INDESIT company

Model type:
AVTF129EU

Commercial code:
F033202

n1040345: Replacement of drum lock button TL EVOII.

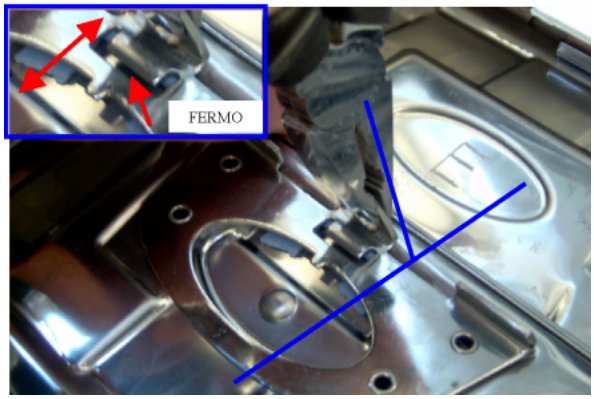
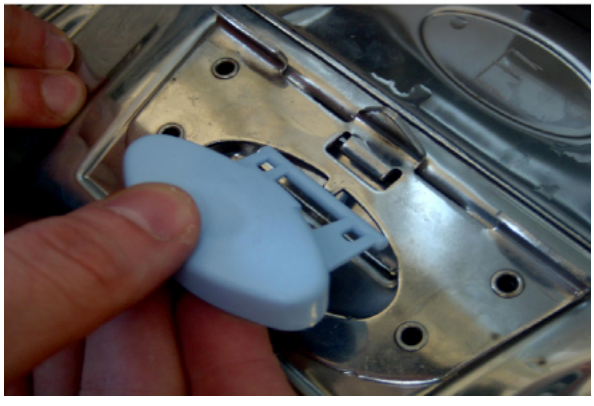
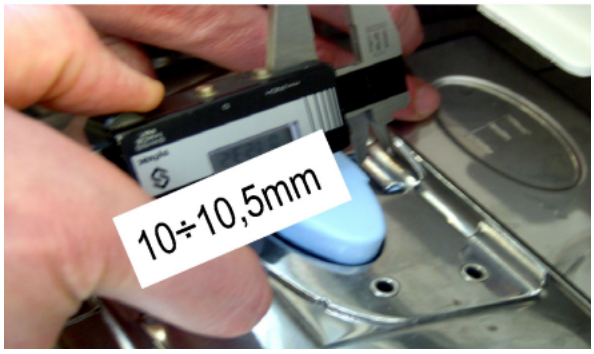
1) turn the central tip of the catch in the direction shown (FIG.1);

2) bring the tip to a vertical position and ensure that the broken button is disengaged from the catch restraint and can be removed (FIG.2);

3) remove the remaining part of the button with the aid of a screwdriver, taking care not to scratch the doors (FIG.3);

4) pre-assemble spring to button (FIG.4);

5) insert button between catch and door (FIG.5);

6) bring the button into position and arrange the spring in its location in the door (FIG.6);

7) turn the central tip of the catch in the direction shown to return it to its starting position (FIG.7);

8) check the distance between button and catch (FIG.8);

9) check correct operation of the button when opening and closing the doors (slight inclination errors of the catch can result in faulty closing of the doors) (FIG.9).

Tools and material needed: pliers, screwdriver, gauge, spring P/N Sat 114989, button P/N Sat 114990.

n1040388: 3.5 three phase module introduced - top-loading Brembate

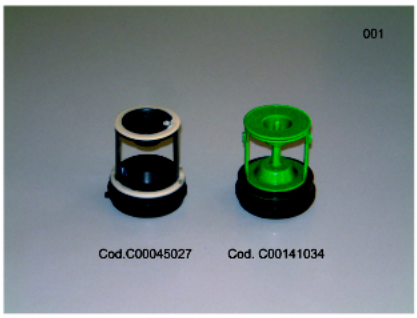
From serial no. 51020.0001 a new 3.05 three phase module has been introduced.
The modification affects the following parts:
-module
-eeprom
-cables (for washing machine with tub lock only)

New parts:
C00265676 three phase module 3.5 - for models with conducibility sensor
C00254298 three phase module 3.5 - for models without conducibility sensor
C00141995 - tub lock cables

Premodification parts:
C00108982 - three phase module
C00112822 - tub lock cables

The spare parts warehouse is not managing the premodification module C00108982, so the new 3.5 C00254298/C00265676 can be fitted on the premodification models using the new setting file the new tub lock cables (on products with tub lock).

ATTENTION!! USING THE NEW MODULE ON PREMODIFICATION MODELS, WHEN YOU DOWNLOAD THE SETTING FILE WITH PALM YOU MUST SELECT A SERIAL NUMBER AFTER THE MODIFICATION.

n4008f00: Thermic link wire removed on three-phase motor

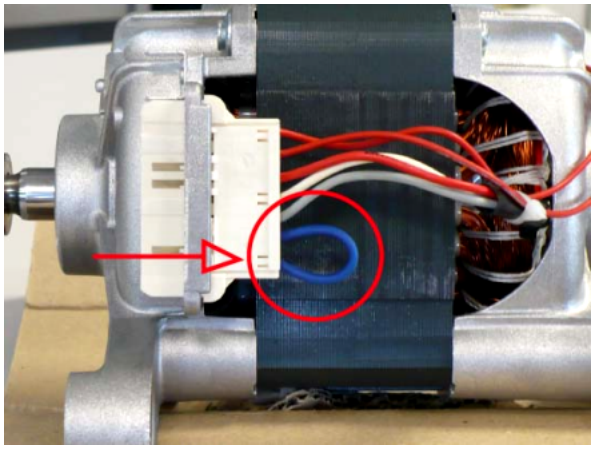
Attention!
When you assist the premodification models using the new motor code you MUST use the thermic link wire code C00265838.

In the attached image you can see the fixing of thermic link wire in the motor therminal box.

TRIPHASE P32 46 L TOP LOADING
C00265832 new motor without thermic link wire - C00262375 premodification motor with thermic link wire
